NRC Public Meeting – March 6, 2025

NEI 11-02, “Change Management Plan – Evaluated Force-on-Force Exercises”

*Division of Security Operations
Office of Nuclear Security and Incident Response*

NEI Proposed flowchart:

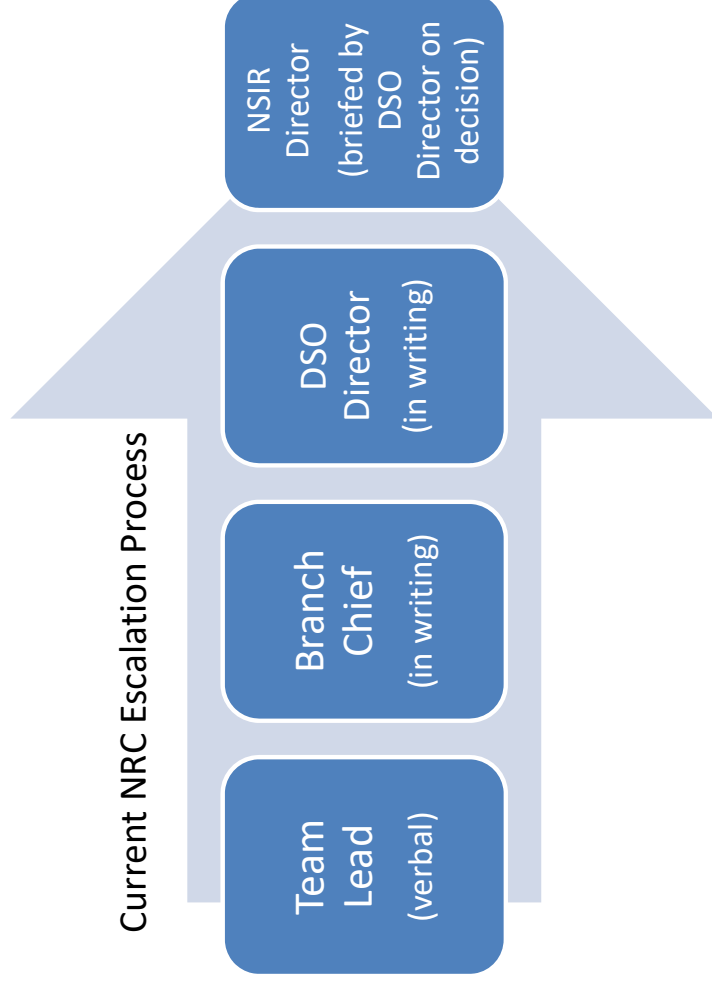
- If a Criteria 1 or 2 item cannot be resolved within 4 days, appeal is to the NSIR director.

- NRC resolves Criteria 1 and 2 at the DSO Director level (not the NSIR Director) if cannot be resolved within 4 days.
- Add formalized call between NSIR Director and their licensee counterpart.
- TL has 2 days to resolve dispute; BC has 2 days to resolve dispute (rather than the 4 days they each currently have).

“Exercise Control Issue (Criterion 3)” – “Does the site have an adequate controlling measure that can be implemented safely”

- Reinforce the regulatory requirements for conducting exercises, including the control and simulation
- Clarify that this is an NRC decision and add decision blocks
- Could result in an inspection finding

- Should be at licensee’s discretion and not part of the official process.
 - How would it be implemented regarding trusted agents?
- How much time would a panel take? (i.e., would it unnecessarily slow down the process)

- Clarify that this is an NRC decision
 - Clarify whether this is business or calendar days
- For Criteria 4/5 - Box should be BEFORE “Review and develop basis for acceptance or denial”

- Revise to a question for a licensee’s choice to appeal
- Conforming changes for yes/no boxes
- Add NRC decision block

“Develop Alternate Scenario”	• NRC needs to be the decisionmaker just before this box • Clarify this is NRC’s role
-------------------------------------	---

“Document in Attachment 4 and Submit to NEI”	• Share access to NEI’s database of disputed items with NRC
---	---

“NRC Policy or Reasonable Assurance – Meets Entry Criteria 4 or 5” – “Review with NEI and Industry Peer Team”	• Do not proceduralize NEI’s role • Industry Peer Team – will this slow the process down? • Please provide hypothetical examples demonstrating the process for each entry criteria
--	--

- Clarify this is NRC’s role
- For complex policy matters, the NRC will be challenged to evaluate the issue and respond in 4 days

- Change to “clarification call with licensee” for the purpose of understanding the problem statement

- Clarify that these follow-on steps are for the tactic in dispute not the alternate scenario (same comment applies to Entry Criteria 1 and 2)
